Work Order ID 95695

Item Name: Gusset

DESIGN <i>CP</i>	DRAWN BY <i>CP</i>	DART AEROSPACE LTD HAWKESBURY, ONTARIO, CANADA	
CHECKED <i>#</i>	APPROVED <i>#</i>	DRAWING NO. D3016	REV. A SHEET 1 OF 3
DATE 01.05.18		TITLE SEAT FRAME ASSEMBLY	SCALE NTS
A	01.05.18	NEW ISSUE

DRAWING NO. D3016	TITLE SEAT FRAME ASSEMBLY	REV. A	DART AEROSPACE LTD ENGINEERING ORDER	D.E.O. NO. D3016-A-1	SHEET NO. SHEET 1 OF 1	SCALE NTS
DRAWN 1	CHECKED UP	MFG. APPR. E	APPROVED MAP	DE APPR. H		
DATE 10.01.29	DATE 10.01.29	DATE 10.01.29	DATE 10.01.29	DATE 10.01.29	DATE 10.01.29

D3016-11 SADDLE

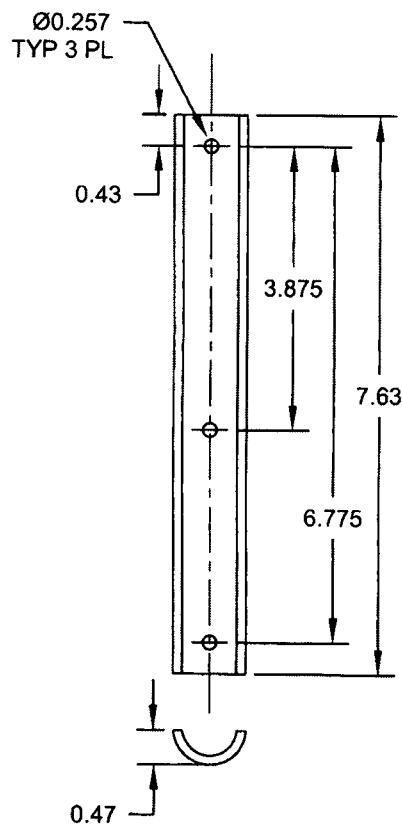
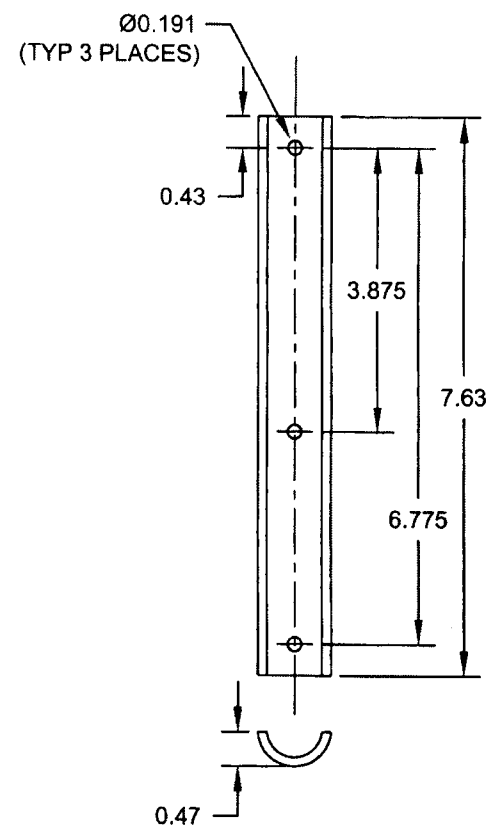
TO REVISE D3016-11 SADDLE'S HOLE SIZES

DETAIL D3016-11 SADDLE (SHEET 3): Ø0.257 TYP 3 PL WAS Ø0.191 (TYP 3 PLACES) AS SHOWN:
